Product Change Notification (PCN)

PCN #: 4L-2025

Date: April 21, 2025

Ezurio Part Number	Description
453-00003	Module, SU60-SOMC, 1Gb RAM
453-00004	Module, SU60-SOMC, 2Gb RAM
453-00137	Module, SU60-SOMC, 1Gb LPDDR2
453-00138	Module, SU60-SOMC, 2Gb LPDDR2
453-00032	Module, Custom SU60-SOMC, 2Gb RAM with Custom Software
453-00073	Module, SU60-SOMC, 1Gb RAM with Custom Software
453-00092	Module, SU60-SOMC, 1Gb RAM with Custom Software
453-00106	Module, SU60-SOMC, 1Gb RAM with Custom Software
453-00121	Module, SU60-SOMC, 1Gb RAM with Custom Software
453-00123	Module, SU60-SOMC, 1Gb RAM with Custom Software
453-00124	Module, SU60-SOMC, 1Gb RAM with Custom Software
453-00132	Module, SU60-SOMC, 1Gb RAM with Custom Software
453-00133	Module, SU60-SOMC, 2Gb RAM with Custom Software
453-00149	Module, SU60-SOMC, 1Gb RAM with Custom Software
453-00182	Module, SU60-SOMC, 2Gb RAM with Custom Software
453-00190	Module, SU60-SOMC, 1Gb RAM with Custom Software
453-00227	Module, SU60-SOMC, 2Gb LPDDR2 with Custom Software

After (453-00137 in the exemplary photo)

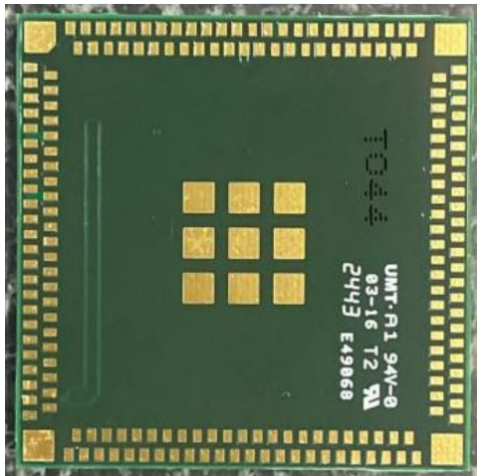
- Carton label changes COO from Made in China to Made in Vietnam

5.2 PCB Silkscreen

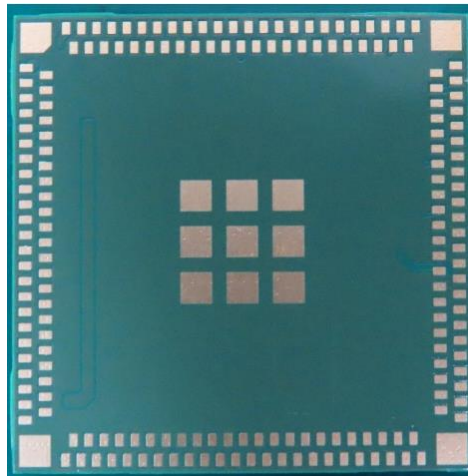
- 453-00003/453-00004/453-00032/453-00063/453-00092/453-00106/453-00121/453-00123/453-00124/453-00132/453-00133/453-00149/453-00182/453-00190, remove the PCB bottom side silkscreen and move it to the top side, as indicated by the red-marked area. Removal of silkscreen on PCB bottom will be a running change after consuming existing PCB inventory.

- Expansion of manufacturing footprint, outside of Taiwan.
- Remove the PCB bottom side silkscreen from non-LPDDR2 PNs to prevent PCB unevenness from causing SMT issues.
